U.S. Department  
of Transportation  
**Federal Highway  
Administration**

March 22, 2005

In Reply Refer To: HSA-10/WZ-200

Thank you for your letter of January 28, 2005, requesting Federal Highway Administration (FHWA) acceptance of your company's MB-42 x 45 high-density polyethylene (HDPE) units as crashworthy traffic control devices for use in work zones on the National Highway System (NHS). Accompanying your letter were drawings of both the original and newly designed units and material specifications for them. You requested that we find the new devices acceptable by virtue of their similarity to the original units you had tested under the provisions of National Cooperative Highway Research Program (NCHRP) Report 350 "Recommended Procedures for the Safety Performance Evaluation of Highway Features." You asked that they be accepted as a Longitudinal Channelizing Barricade at test level 1 (TL-1) when linked together and as TL-3 Manual Uniform Traffic Control Devices Type II Barricades when they stand alone. You also followed up with additional information on March 10, 2005.

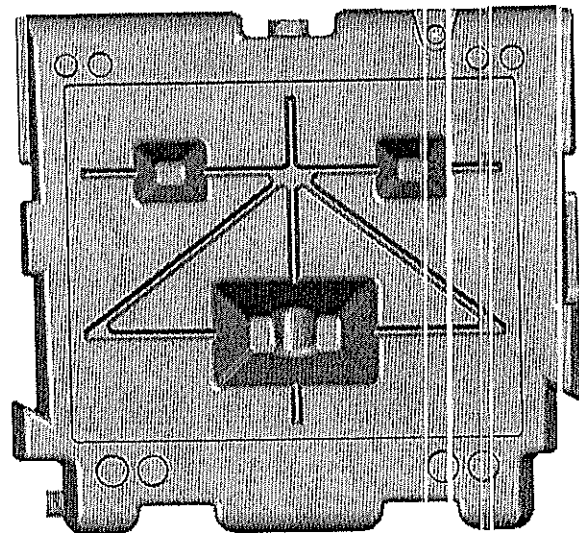
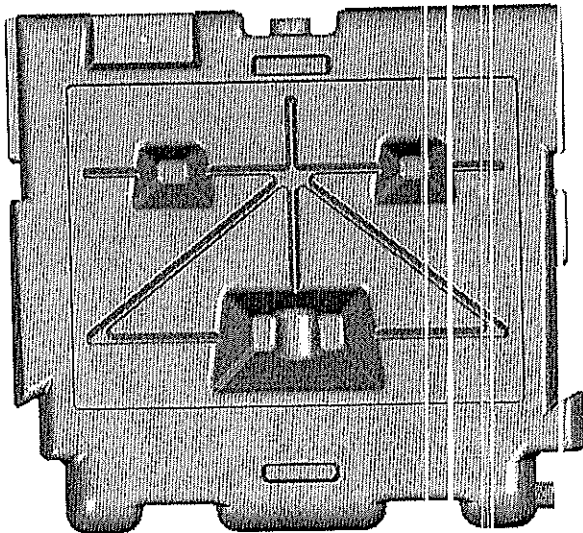
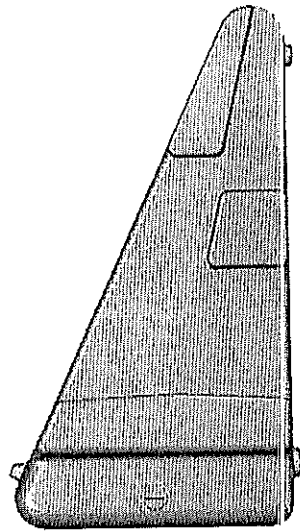
The new MB-42 x 45 HDPE units are blow molded with HDPE and measure 40 inches long and 48 inches tall. Each section is 22.5 inches wide at the base, tapering on one side to a top width of 5 inches. The wall thickness is 0.156 inches and a single unit weighs 35 pounds when empty. The new units are 6 inches lower, 5 inches longer, and 15 pounds lighter than the tested units. The maximum water ballast that they can hold is 721 pounds, or 200 pounds less than the crash tested version. Because the tensile strength of the HDPE is significantly greater than that of the low density material, the wall thickness can be reduced using the HDPE and still maintain the strength of the units similar to the LLDPE crash-tested units.

The change in fabrication from a roto-molded product using low-density polyethylene (MB-48 x 40) to a blow-molded product using high-density polyethylene (MB-42 x 45) may affect the performance of the devices. The thinner HDPE walls of the new units are roughly 20 percent stronger than the thicker LLDPE walls in the tested units. You have arranged to have a TL-3 test (NCHRP Report 350 Test 3-10) conducted on the MD-42 x 45 HDPE LCB to assess the high-speed performance of the new units. Assuming the test is successful, you asked that the FHWA consider this test as sufficient to judge the TL-3 performance of the original MB-48 x 40 also. We agree in principal to this request, but reserve final judgment pending our analysis of the crash documentation to verify that performance will be comparable.

Based on the analysis above we concur that the new MB-42 x 45 HDPE units will be acceptable as TL-3 stand-alone Type II barricades and as a TL-1 LCB for use on the NHS under the range of condition that the MB-48 x 40 was tested, when proposed by a State.
